Application No. R43019
Permit No. R 4898
Certificate No. 38903

2.2 af a reservoir and storage of water from Butternut Creek (Tualatin River) for irri-
gation

ADDITIONAL INFORMATION TO BE SUBMITTED WITH APPLICATIONS PROPOSING CONSTRUCTION OF DAMS LESS THAN 10 FEET IN HEIGHT OR IMPOUNDING LESS THAN 3,000,000 GALLONS

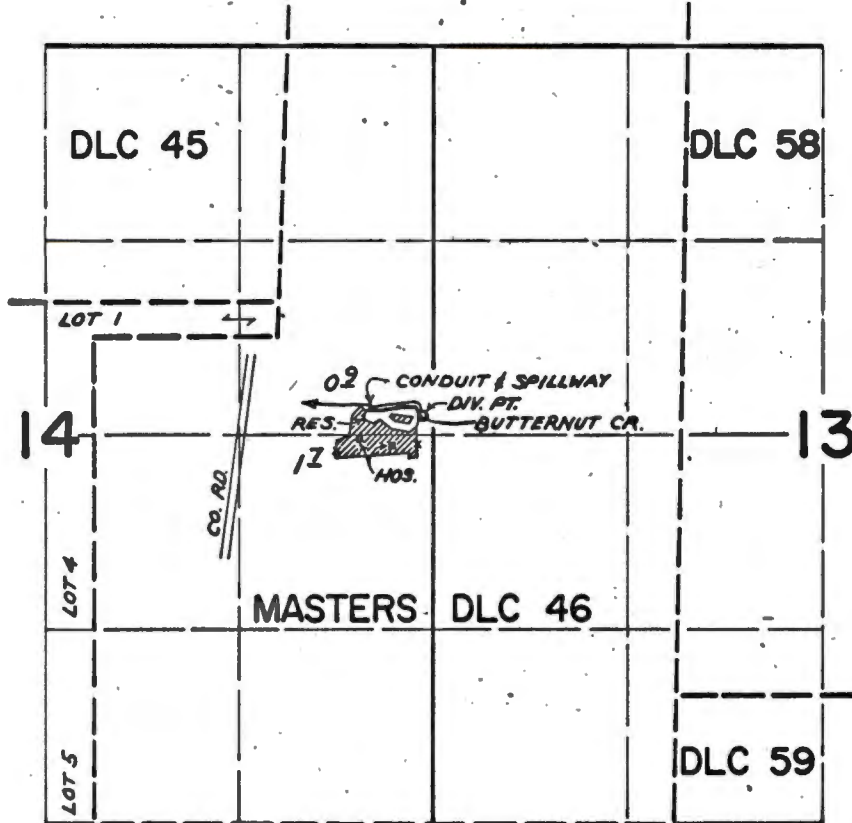
What is freeboard? shows 2', 3' & 6', should be 3.75'

What is length of Dam?

Is spillway over embankment or through undisturbed mat'ls?

Is riprap provided for protection in spillway?

50 yr. flood frequency approx. 400 cfs.

#6 & #7 disagree as to freeboard

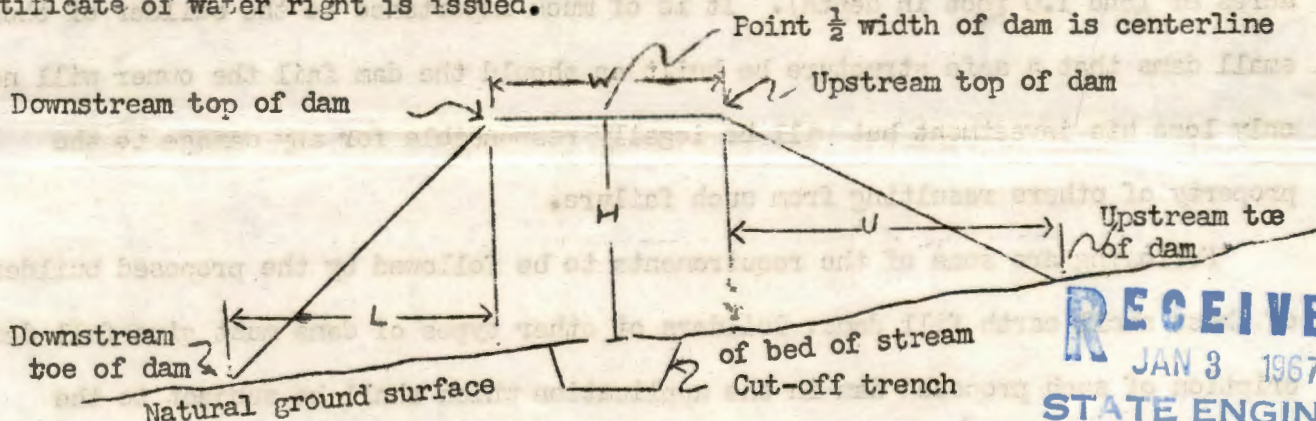
Item No. 6 on the reservoir application indicates the height of dam above highwater line when full as being 6 feet. The height of dam above the highwater line is the freeboard. - The small dam data sheet now indicates the depth of spillway as being 6 feet. However, item No. 7 on the reservoir application indicates only 3 feet of freeboard above the pool level. These three entries should correspond.

Item No. 6 on the reservoir application indicates the maximum height of dam above highwater line when full, as being six feet. The small dam data sheet indicates the depth of spillway as seven feet. These figures usually correspond. If they do not, would you please explain in the section provided for remarks. Our computation indicates that a minimum depth of spillway of 3.75 feet is required.

Item No. 6 on the reservoir application indicates the height of dam above highwater line when full, as being six feet. The accompanying small dam data sheet indicates the depth of spillway as being only three feet. The height of dam above highwater line and depth of spillway usually correspond. Is the spillway in embankment or natural material? If the spillway is in embankment, do you intend to riprap for protection.

1. Item 6 Reservoir Application - change "height of dam above water line when full" from 6 feet as shown to 3 feet.
2. Small dam data sheet - depth of spillway "h" indicated 6 foot shall be change to 3 feet.

Distance between top of dam and bottom of spillway at the upper end, indicated on sketch by letter "h" is 3.0 feet.
